PRODUCT CHANGE NOTIFICATION

Date: November 06, 2015
PCN: PCN LEDIL 112 a, b, c, d

Subject: **PCN 112.d – EOL notice**

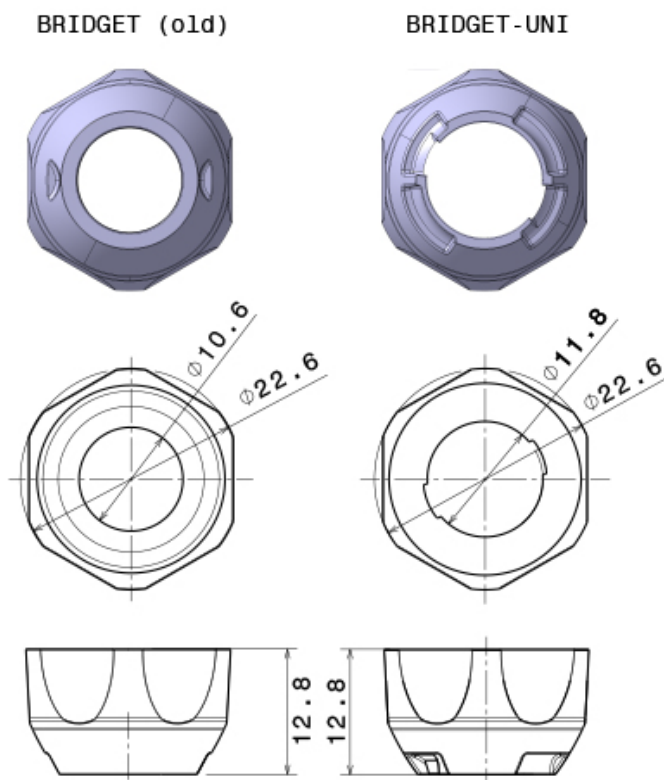
Description: As part of our continuous improvement process regarding the quality of our products LEDiL is planning to obsolete some BRIDGET-family reflectors and replace them with BRIDGET-UNI counterparts due the possible clash with some COBs.

Changes: Products will be replaced as follows.
C10918_BRIDGET-S → **C13557_BRIDGET-S-UNI**
C10919_BRIDGET-M → **C13556_BRIDGET-M-UNI**
C10920_BRIDGET-W → **C13555_BRIDGET-W-UNI**
